National Capital Plan – Amendment 74 – Section 5 Campbell¹

Schedule 1 Amendment

Detailed Conditions of Planning, Design and Development for Section 5 Campbell

f. Delete the existing figure titled 'Indicative Landscape Structure' and replace with the following:

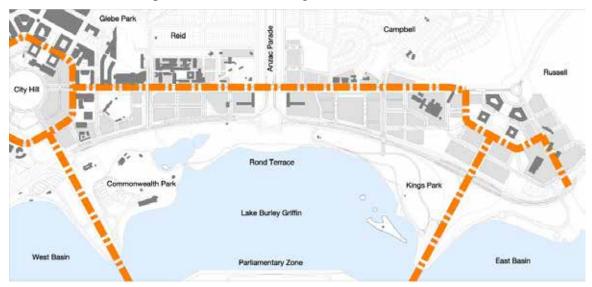
d. Delete the existing figure titled 'Indicative Urban Structure' and replace with the following:

e. Delete the existing figure titled 'Indicative Main Pedestrian Connections' and replace with the following:

m. Delete the existing figure titled 'Indicative Building Height and Form' and replace with the following:

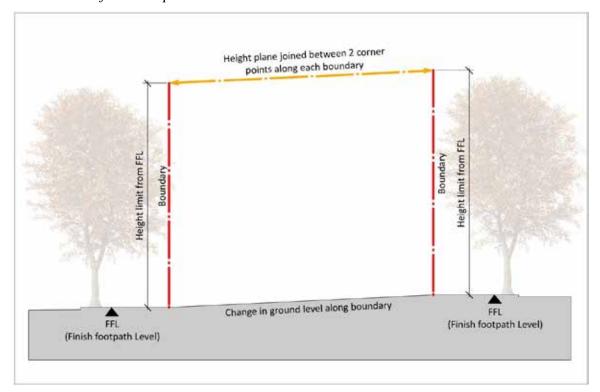
1. Delete the existing figure titled 'Indicative Active Frontage' and replace with the following:

o. Insert a new paragraph and drawing under section titled 'Building Height and Form' as follows:

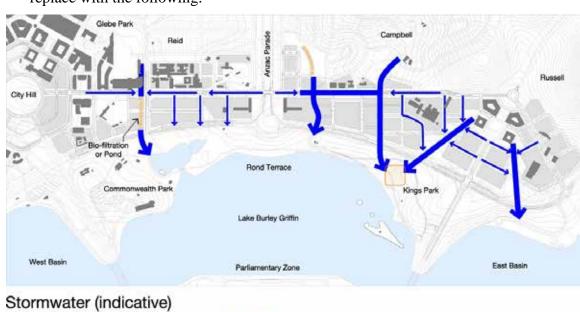
Building height is to be measured from and between the finish footpath level at each corner of a development block.

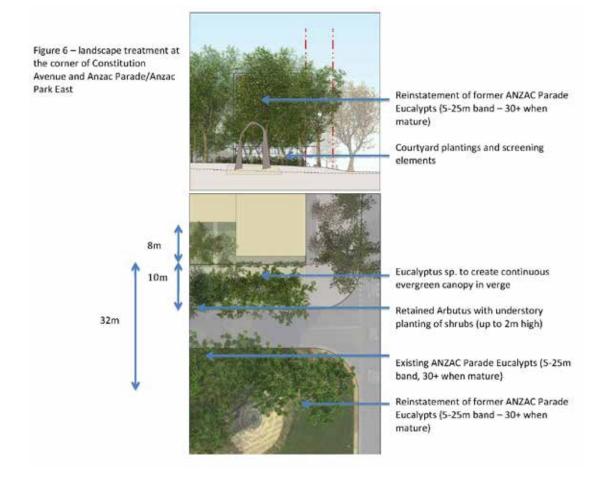
The landscape treatment at the corner of Constitution Avenue and Anzac Parade/Anzac Parade East shall generally be in accordance with Figure 6.

Particular attention shall be given to the building form/façade at the corner of Anzac Parade East and Constitution Avenue. The design of buildings should be articulated using a variety of messing; solids and voids; and materials and colours to ameliorate any impacts on the adjacent National and Commonwealth Heritage listed places.

Buildings should not intrude on the public appreciation of the eastern handle of the New Zealand Memorial as the gateway to the Memorial Parade or interrupt the symmetrical characteristics of the East and West portal buildings in framing the Parliament House Vista.
